RE: Ceja Vista Unit 1A, 1B, 1C, 2A, 2B, & C
Amended Drainage Management Plan
Stamp Date: 04/24/18
Hydrology File: P09D002E

PO Box 1293 Based upon the information provided in your resubmittal received 04/25/18, the Amended
Drainage Management Plan is approved for action by the DRB on the Preliminary Plat.

**Re: Ceja Vista Unit 1A, 1B, 1C, 2A, 2B, 3
Amended Drainage Management Plan
Engineers stamp date 4-18-18 (P09 / D002E)**

RE: Ceja Vista Unit 1A, 1B, 1C, 2A, 2B, & C
Amended Drainage Management Plan
Stamp Date: 03/30/18
Hydrology File: P09D002E

MASTER DRAINAGE PLAN

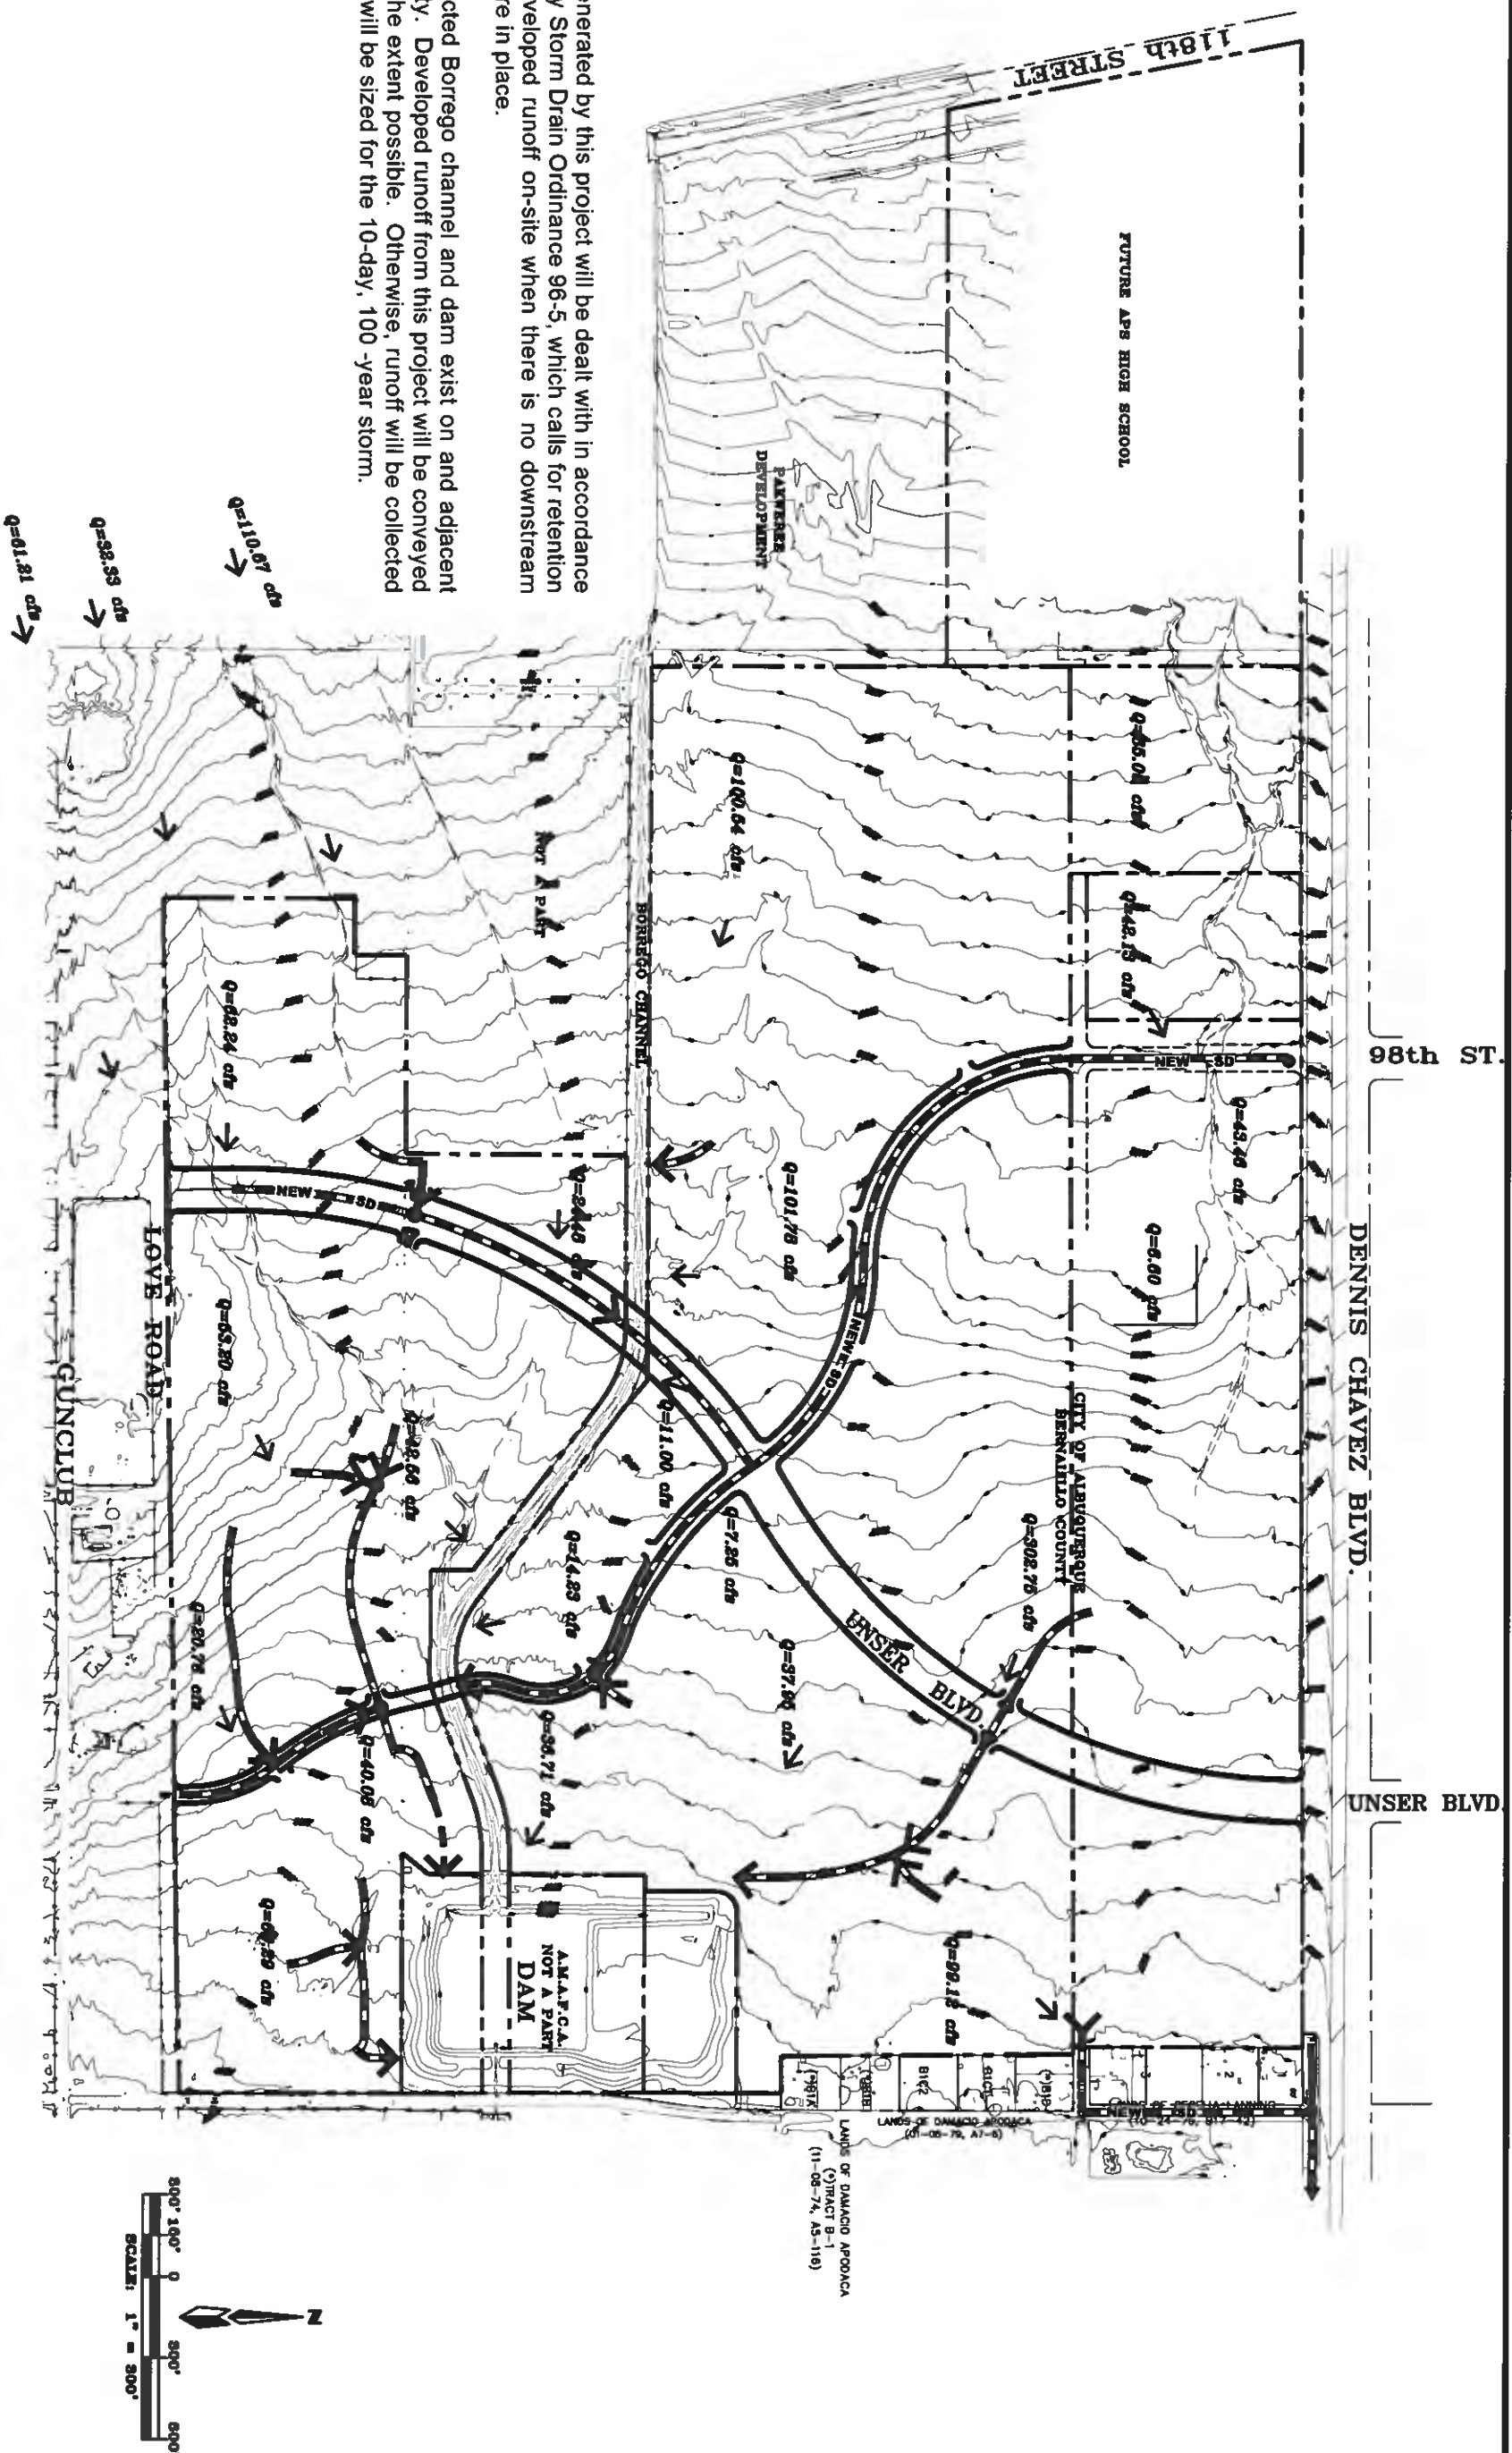
6. Amended Drainage Management Plan. Please label the Master Drainage Plan that was provided as "within Bernalillo County".
7. Amended Drainage Management Plan. Please add the attached Master Drainage Plan, update with the new drainage system, and label as "within City of Albuquerque".

- 7. The City Drainage Management Plan exhibit has been updated and added to the report.*
- 8. The AHYMO print outs and table summary have been added to this report.*

CEJA VISTA - UNIT 1
GRADING & DRAINAGE PLAN

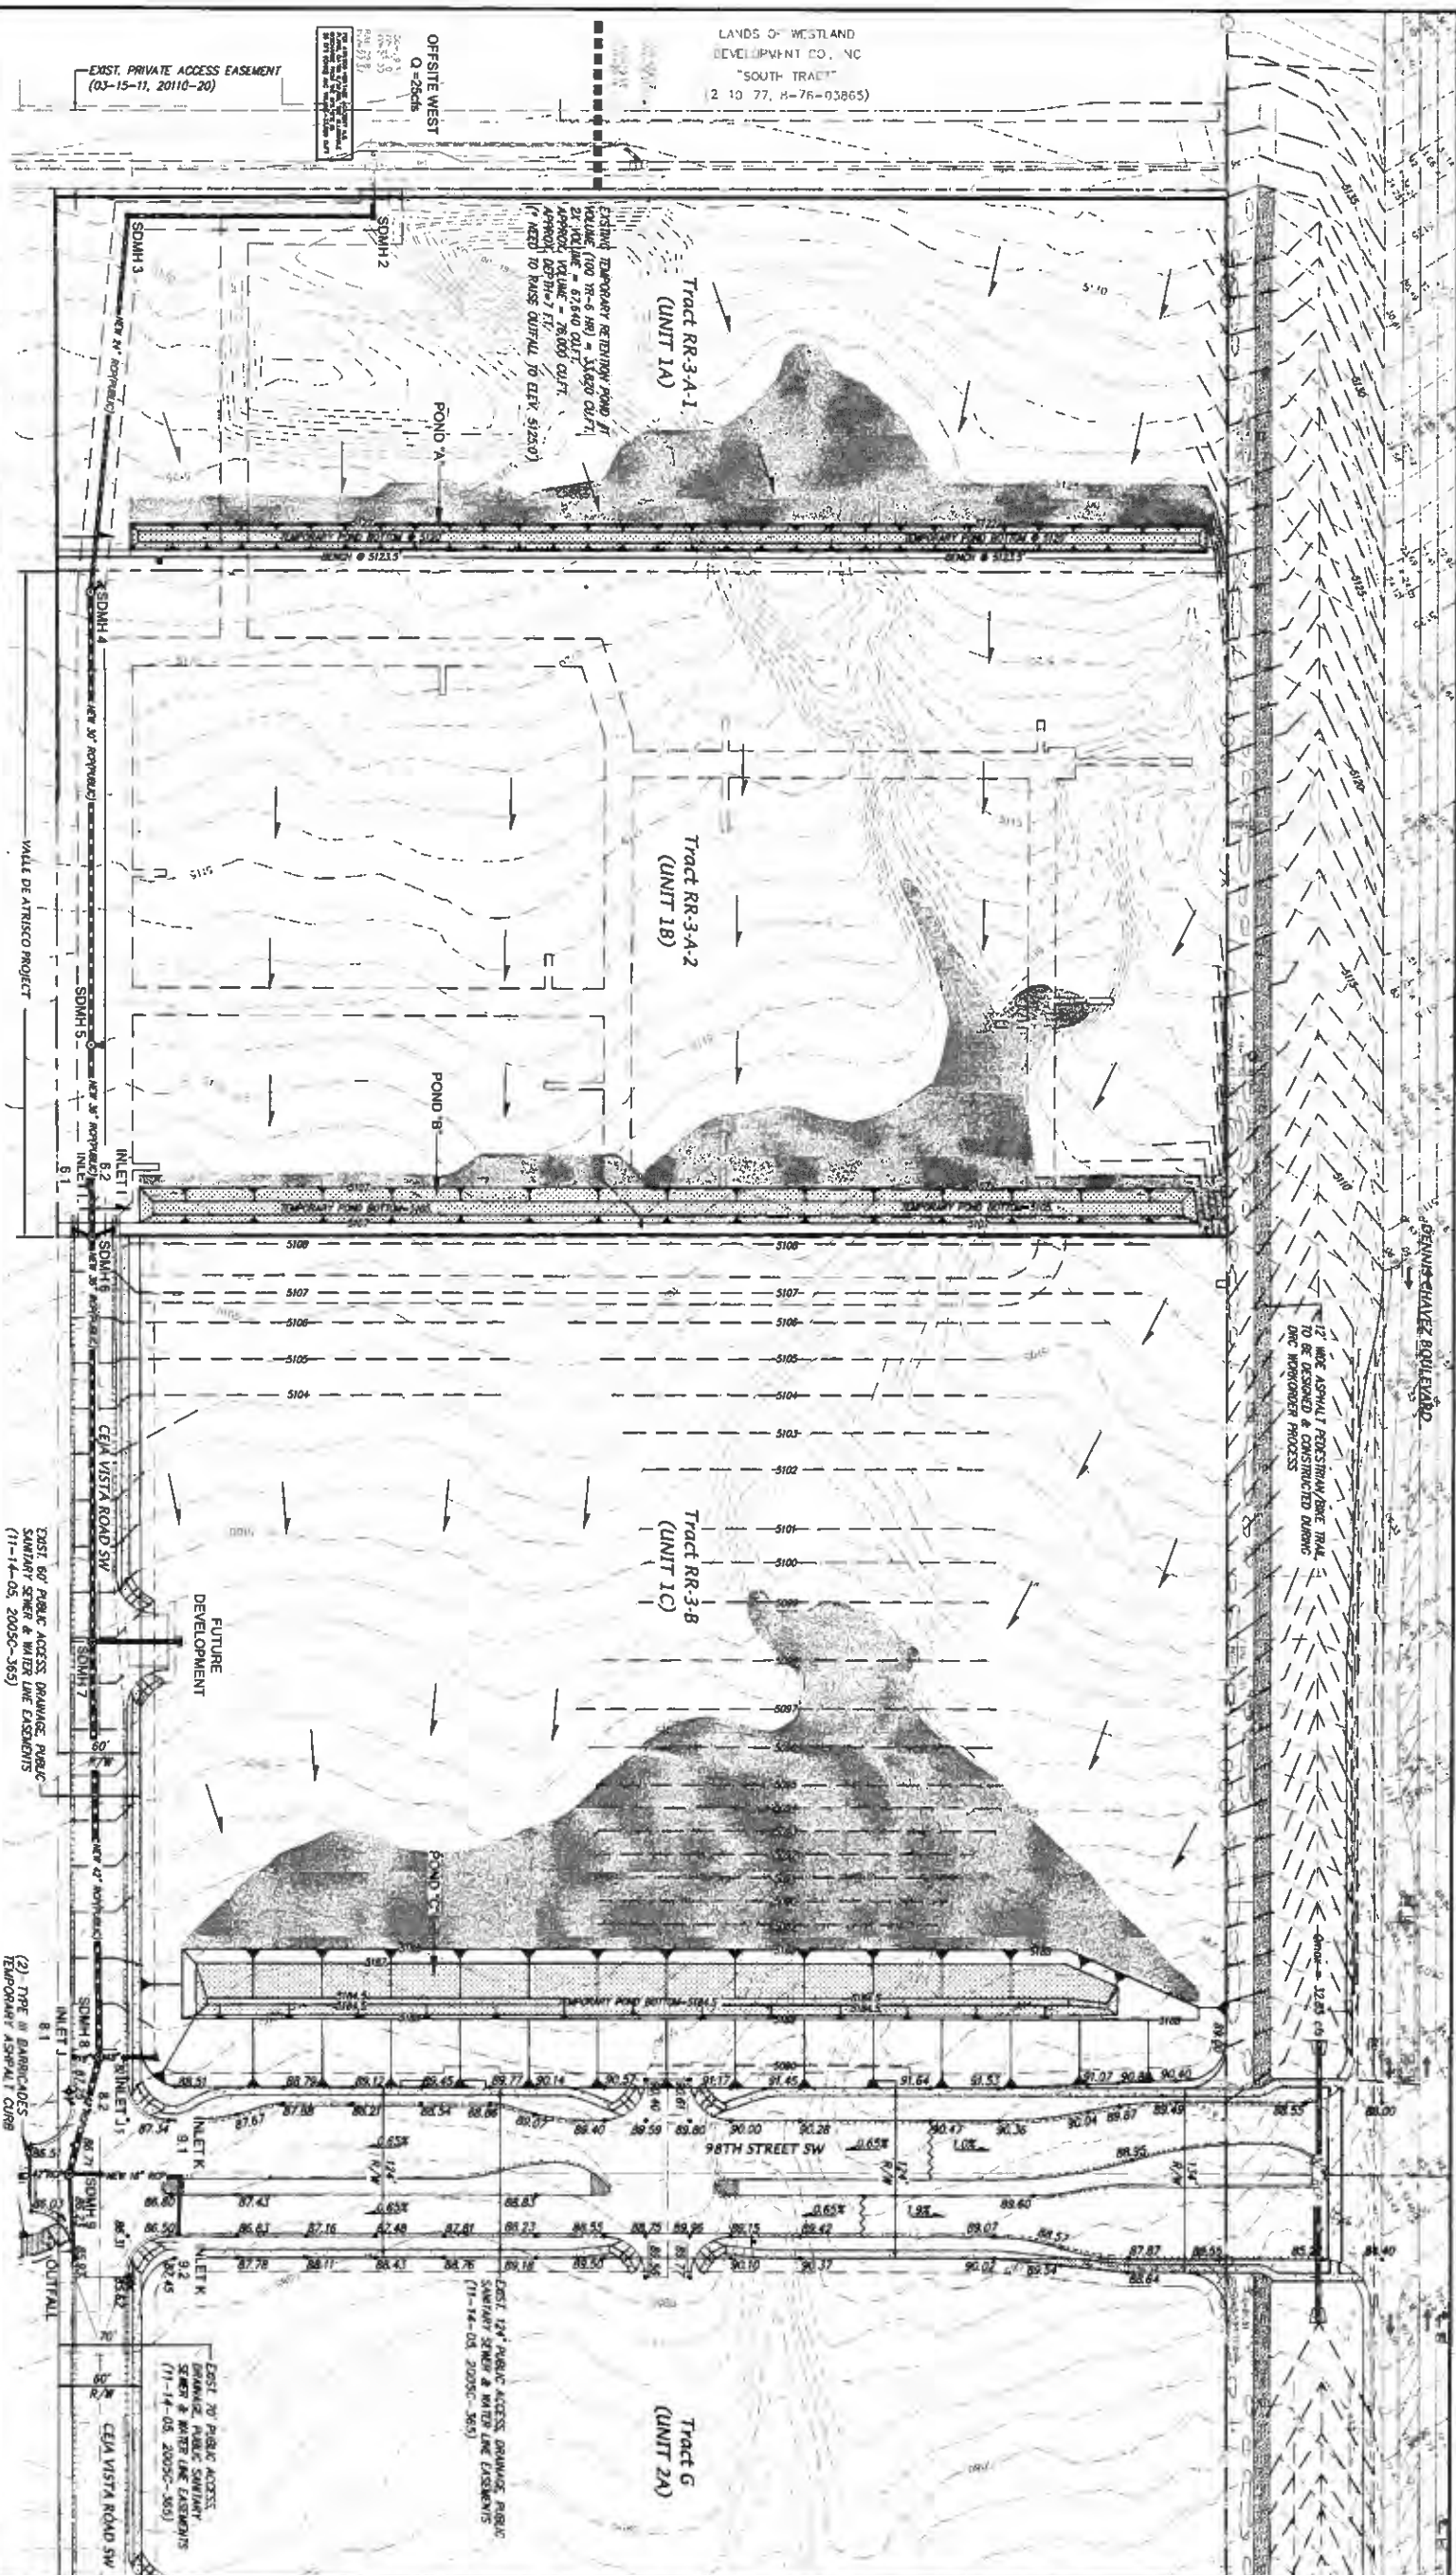
12. Grading and Drainage Plan. Please number the sheets 1 of 2 and 2 of 2.
13. Grading and Drainage Plan Sheet 1. Please label the Tracts per the plat (i.e. Tract RR-3-A-1) and not Tract A, B, & C.

14. Grading and Drainage Plan Sheet 1. Please fix the vicinity map to include Tract RR-3-B, 98th street, and the offsite drainage channel & temporary retention pond within Bernalillo County.

15. Grading and Drainage Plan Sheet 1. Please label the diversion / temporary ponds on each Tract and in the calculation table.
16. Grading and Drainage Plan Sheet 1. Please connect each proposed diversion / temporary ponds to the proposed storm sewer stub outs.

17. Grading and Drainage Plan Sheet 1. Please add either a Private Cross Lot Drainage Easement at the southwest corner of Tract RR-3-A-2 for the pipe to Tract RR-3-A-1 or move the storm stub out from Tract RR-3-A-2 to Tract RR-3-A-1.

18. Grading and Drainage Plan Sheet 1. Please add a public turn-a-round at the end of Ceja Vista Road and provide grading for the turn-a-round.
19. Grading and Drainage Plan sheet 1. Please provide a section along Dennis Chavez showing the proposed ditch and show a trapezoidal section per the design calculation in the Amended Drainage Management Plan. Again maintenance must be accepted by NMDOT or change to curb and gutter.

20. Grading and Drainage Plan Sheet 1. Remove the arrows and label of "Valle de Atrisco Project". All work within Dennis Chavez will be done with this Grading and Drainage Plan.

21. Grading and Drainage Plan Sheet 1. Please show the proposed pavement returns for 98th Street at Dennis Chavez.
22. Grading and Drainage Plan Sheet 1. Please provide the 30 inch culvert inverts.

- 11. Grading plan label has been revised.*
- 12. Sheet number revised.*
- 13. Tract A, B, C has been changed to RR-3-A-1, RR-3-A-2 and RR-3-B.*
- 14. The vicinity map has been updated.*

- 15. The labels for the temporary ponds have been updated as requested.*

16. Per our discussion, these temporary ponds are not to be connected to the public storm drain.
17. The public storm drain system is included through Tracts RR-3-A-1 and RR-3-A-2. The stubs are private and each one will be within their own tract.

18. The temporary turnaround requirement has been worked out with transportation and will be the stub entrance driveway in the middle of Tract RR-3-A-2 off of Ceja Vista Road.

19. The details of this swale along Dennis Chavez will be worked out with NMDOT during the design stage. At this time, it will be on the infrastructure list as an item to be designed during construction plan preparation stage. We are working on getting approval of maintenance responsibility acknowledgement from the NMDOT.

20. Valle De Atrisco label has been removed.
21. The asphalt radius connection between 98th street and Dennis Chavez has been added.
22. The culvert inverts under 98th street will be determined during design phase.
